City of Woodburn
Community Development Dept.

Memorandum

Date: March 30, 2023
To: Dago Garcia, P.E., City Engineer
Cc: Roy Reyes, Project Engineer
Chris Kerr, AICP, Community Development Director
John Raugust, PE, AKS Engineering & Forestry
From: Colin Cortes, AICP, CNU-A, Senior Planner *CC*
Subject: **Planning Division review comments on 2nd / 1st revised submittal March 2 of civil engineering plans for Marion Pointe PUD**

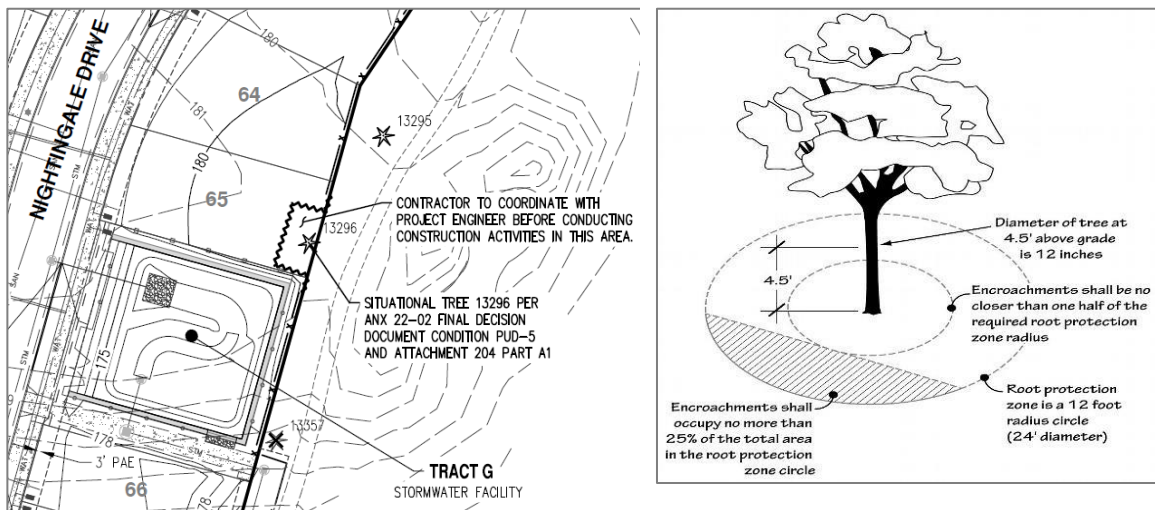
O4c: Tract G: Revise site plans including Sheet L106 to meet INT 22-0608 Part B3b, i.e. to set back the path from the tract south boundary “min width either 5 ft each or 8 ft on south, southwest, or west side of facility and 2 ft on remaining north, northeast, or east side”. Revise Sheet L106 also to label the path as Path G.

The developer’s response was:

“The property lines that were shown in the land use application provide 17.0’ of width between the face of the stormwater facility retaining wall and the Tract G/Lot 66 common property line. The Ped-1 path (10.0’ concrete) was located in the center of this available width, providing 3.5’ of clearance between both edges of the concrete path. Please confirm if the City would like us to reduce the spacing on the south property line to 2.0’. Doing this would provide 5.0’ of spacing between the face of the stormwater facility retaining wall and the concrete path.”

Revise to have 5 ft width along the south of Path G and 2 ft along the north.
